Strathcona Junction Planning Study

Advisory Committee Meeting Summary

DRAFT DEVELOPMENT CONCEPT

May 29, 2008

Map 7: Development Concept

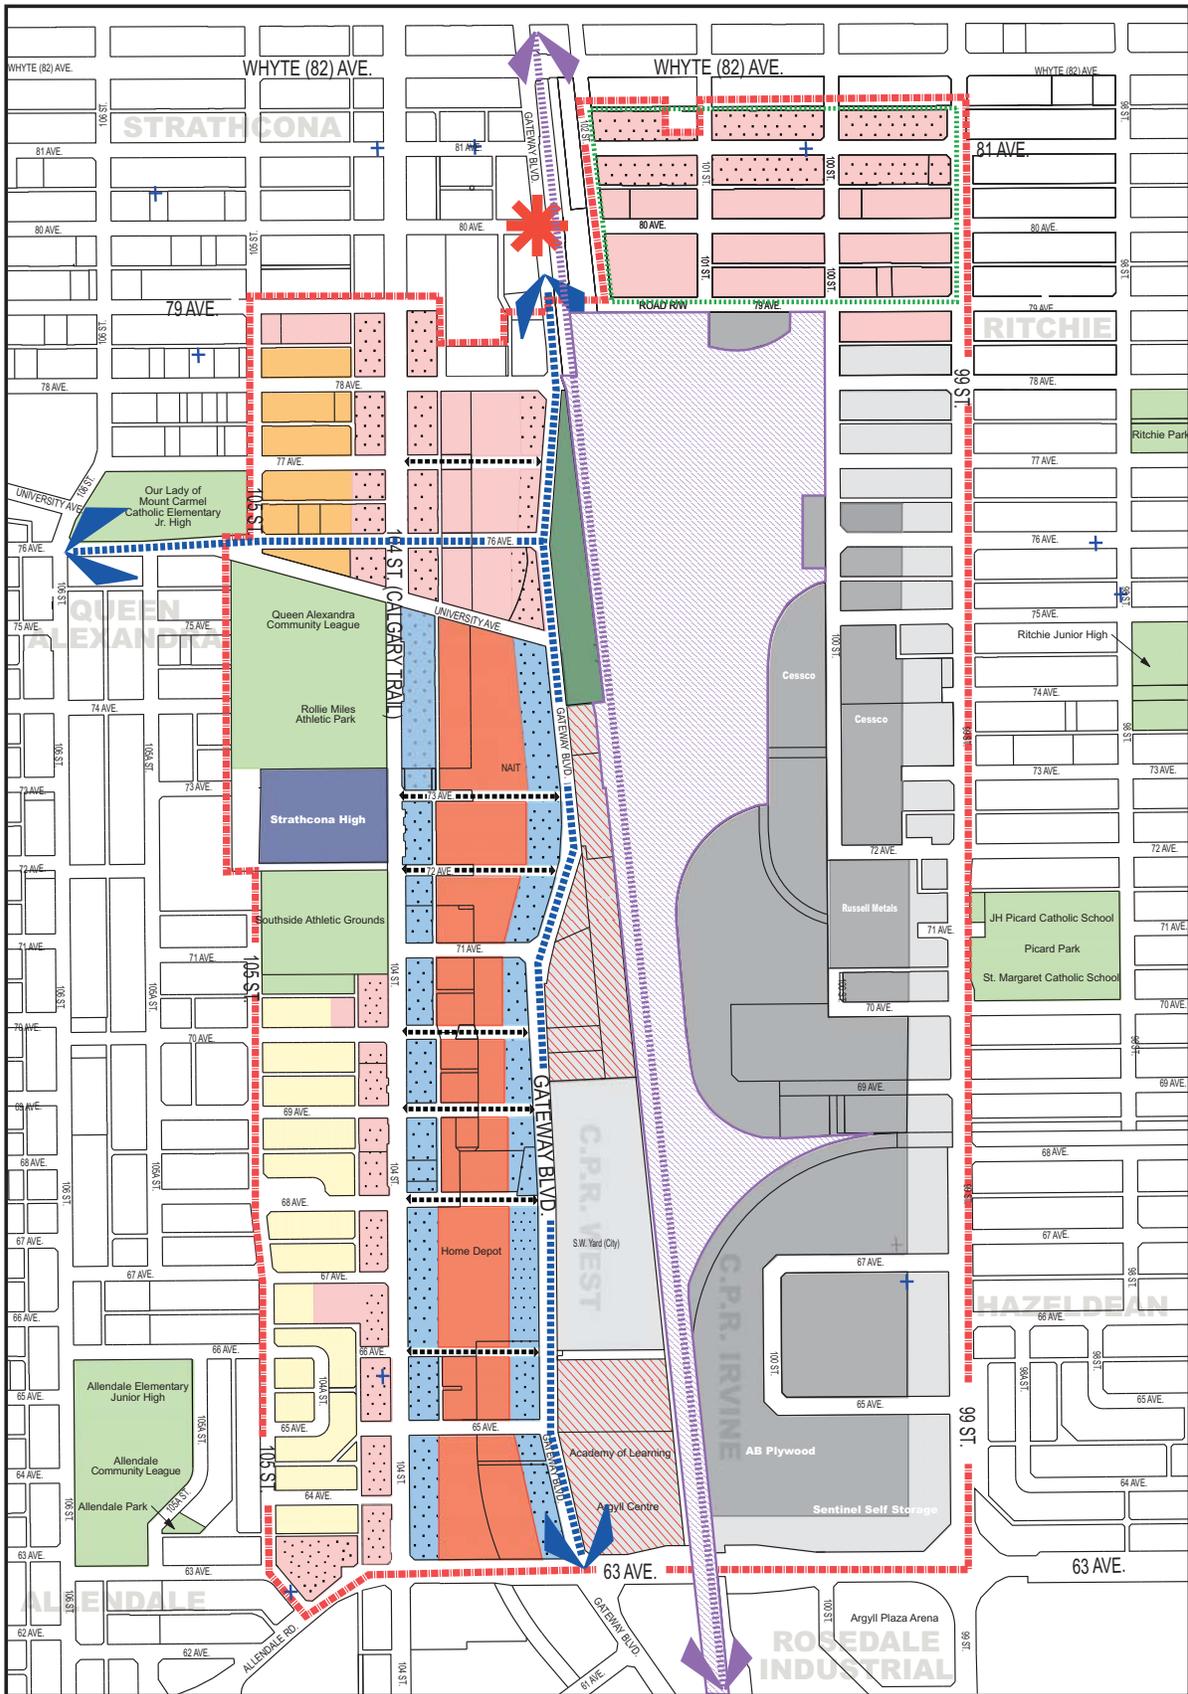
- Diane M. asked what the City's intentions were regarding transportation in the area as nothing was shown on the Development Concept map.
 - Georgina stated she thought the proposal was great, but wanted to make sure street widening is not a future intention. She asked if there was any way to guarantee that there would be no future expansion of traffic lanes on 104 Street and Gateway Boulevard in the face of increased density.

- Georgina pointed out that the South Side Athletics Ground becomes a swamp in spring and it's almost impossible to walk through. She said the City might want to address this issue in the Development Concept.

- Julie explained the proposal for improving and adding crosswalks along the three north-south arterials in the study area.
 - Gary pointed out that 80 Avenue offers direct access down to the Mill Creek Ravine and the City may want to look at improvements to the 80 Avenue and 99 Street intersections to take advantage of the ravine access ramp. He stated there is a lot of bike traffic on that street already (although it's not officially identified as a bike street). He believes 80 Avenue could offer a recreational connection to the ravine in the form of a multi-use trail.

- Diane D. suggested that 83 Avenue be identified as a bicycle street on the map since it's identified as such in the City's Bicycle Transportation Plan.

- Georgina asked if there was any way to incorporate access over the rail yards as no new connections are proposed in the Development Concept map.
 - Rick stated that CP would have an issue with that because the width of the yard would most likely require a supporting post to be constructed somewhere on the yards and there would be no way to reconfigure the existing tracks to accommodate such a structure. He stated CP would not allow such a structure to be built over their yard. He went on to state that if there was some way to build a structure that starts on city land and ends on city land with no support columns required, which is more doable at the southern end closer to 63 Avenue, then CP may support such an idea.

- Shirley liked the idea of maintaining the alley to the west because it would allow traffic to circulate without using 104 Street.
 - Julie responded that Planning and Development will work with Transportation as the study moves forward and that early talks with Transportation were positive. She explained that one of the future steps of the Planning Study might be to conduct a traffic planning study. She also explained that while 104 Street and Gateway Boulevard will remain traffic thoroughfares, they will become more pedestrian-friendly.
